Modifications for the Kenwood TR-7400

Service Notes on TR-7400A

Service bulletin no. 32 (19-1-1979)

Arcing in TR-7400A final section

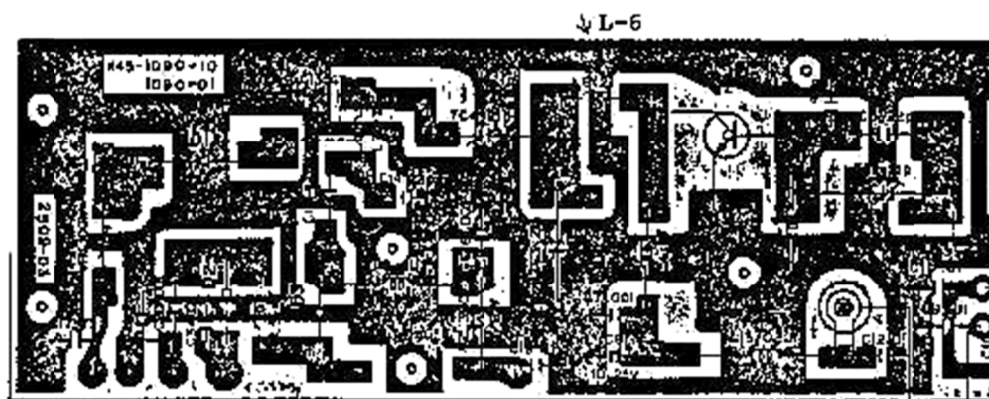
There may be some cases of arcing to ground beneath coil L-6 at the collector of Q-2 (2N6083) inside the final unit X45-10-90-10. This is due to minute differences in the circuit board trace dimensions and a residue of flux on the board.

If this should occur, remove L-6 and clean all traces of carbon and flux from the circuit board. Resolder the edges of the tracer and remove any flux left from soldering. Modify L-6 as shown:

reinstall L-6 and check for rated output. A slight retuning of TC-4 may be required.

Changes in PO Unit of the TR-7400A

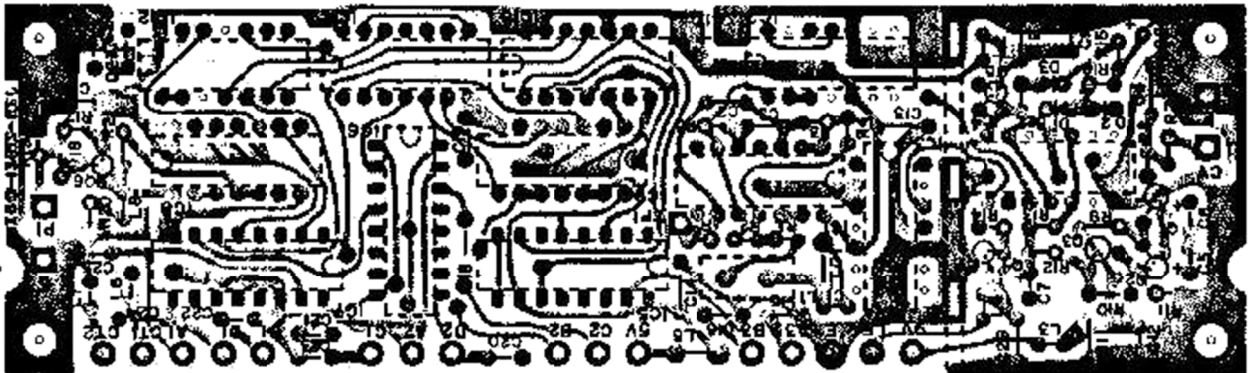
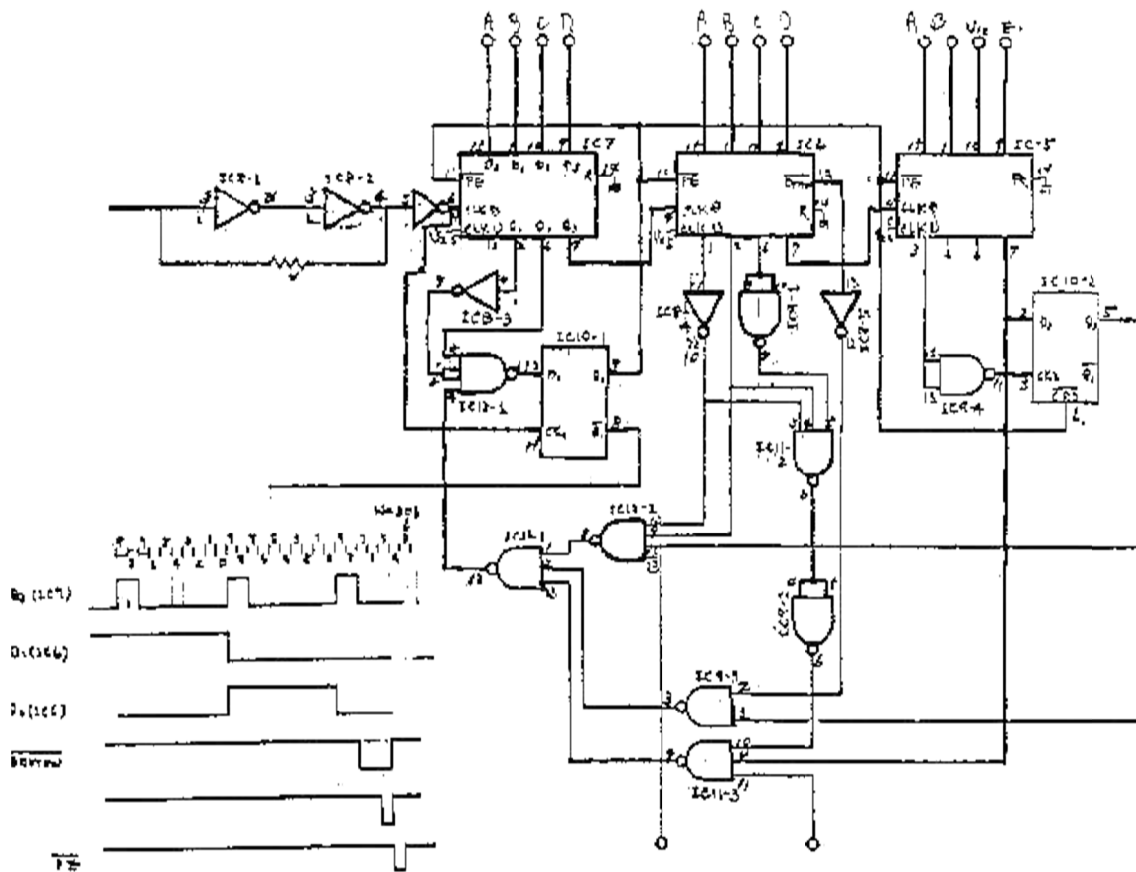
There was a temporary production change in the PO Unit of the TR-7400A. This change effected the 73XXXX and 74XXXX series units only. The change was made because of the Motorola MC-4016P IC was not available. The Texas Instruments SN74LS192 IC was used as a replacement. It is not a direct replacement, though. It was also necessary to change IC-8 from a TD-3400AP to a TD3404. This series of PO Units is easily recognized because of the three SN74LS192 IS's are mounted in sockets instead of being soldered in place. The PC board was changed to J25-2512-03T instead of J25-2512-03 for this change. The schematic is shown below.
